Address: Pending-5401 Congress Ave.-Apartment Building & 3325 Ambassador Drive-Garage  
 Title: The Madison Apartments

Re: The Madison Apartments  
PRA Project No. 160200-01

JANINE GLAESER, At the December 20, 2017 Urban Design Commission (UDC) the Madison Apartments project was presented. The result of this meeting was Initial Approval and a request to respond to four open UDC issues. This submission is intended as the both the response and as a submission to present these requested design clarification items at the April 18, 2018 UDC meeting.

L  
1

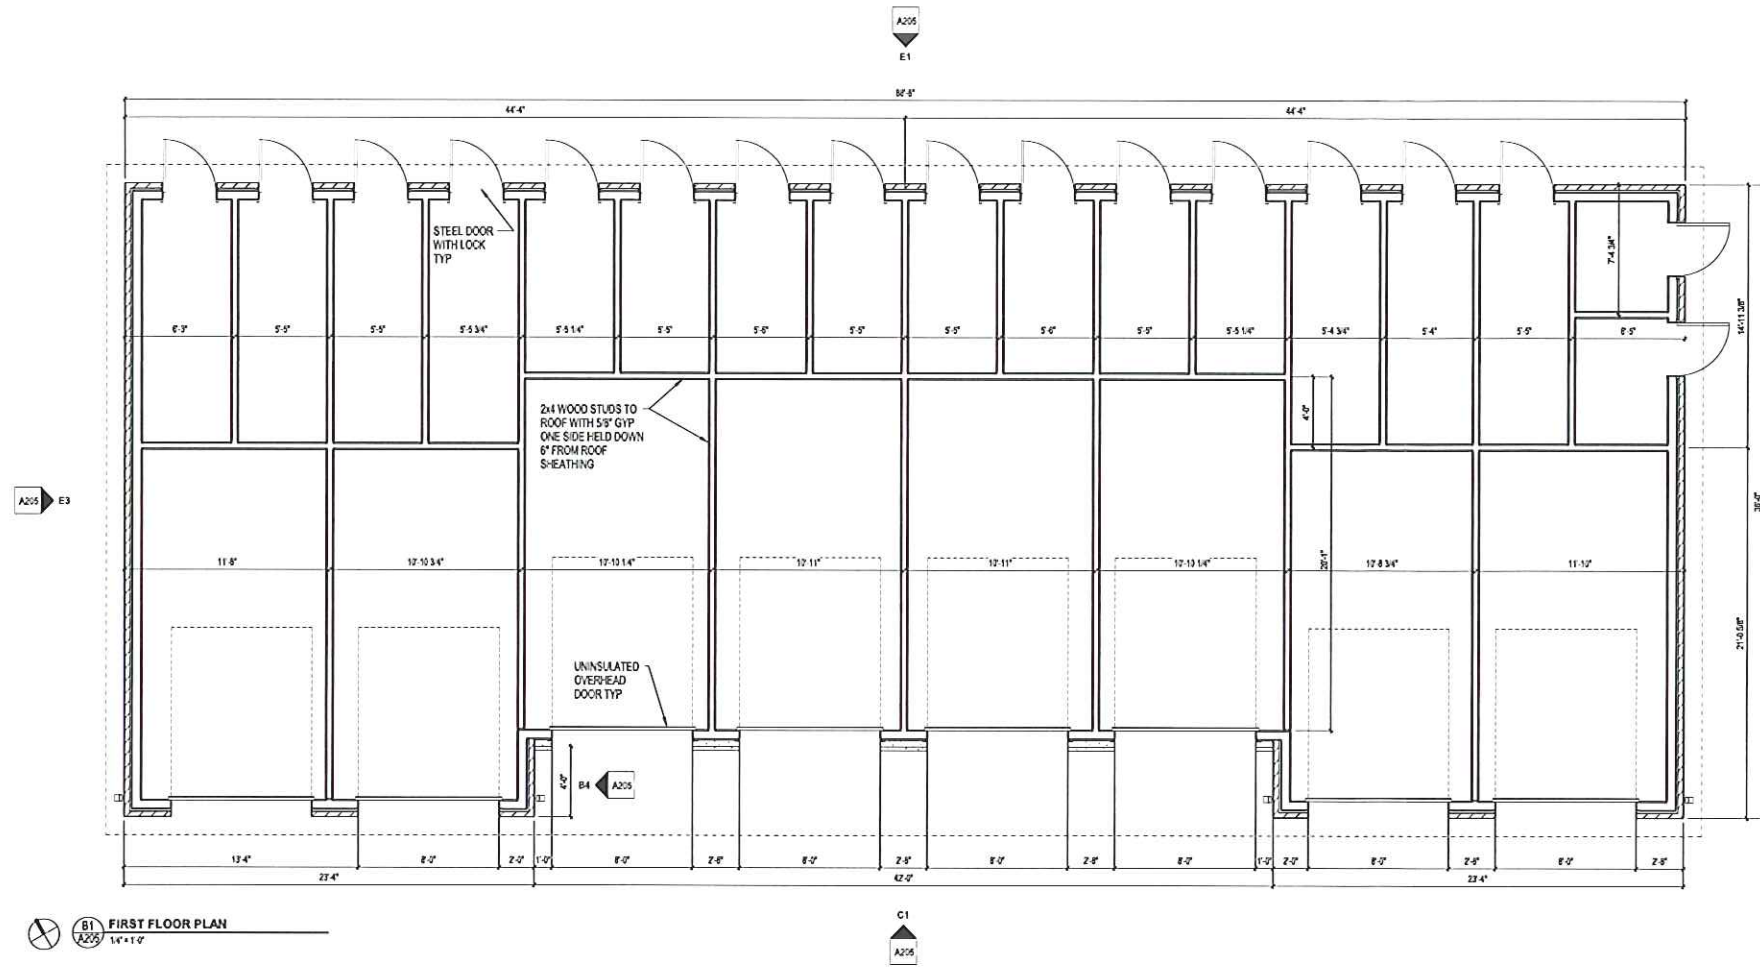
1. Adding additional brick to the Garage/Storage/Gardening structure
2. Relocation of some large canopy trees to address the entry point in a clearer fashion
3. Provide and elevation of the retaining walls along the 'west' elevation and indicate how the plantings integrate with these structures.
4. Provide a few additional notes on the intended retaining wall materials

Each of these issues have been addressed. An additional sheet will be added to this submission on April 5<sup>th</sup> as one of the Landscape Architect graphic documents were not completed as of the required submission date. I kindly ask that this application remain near the front desk of your office to allow me to hand deliver this additional drawing.
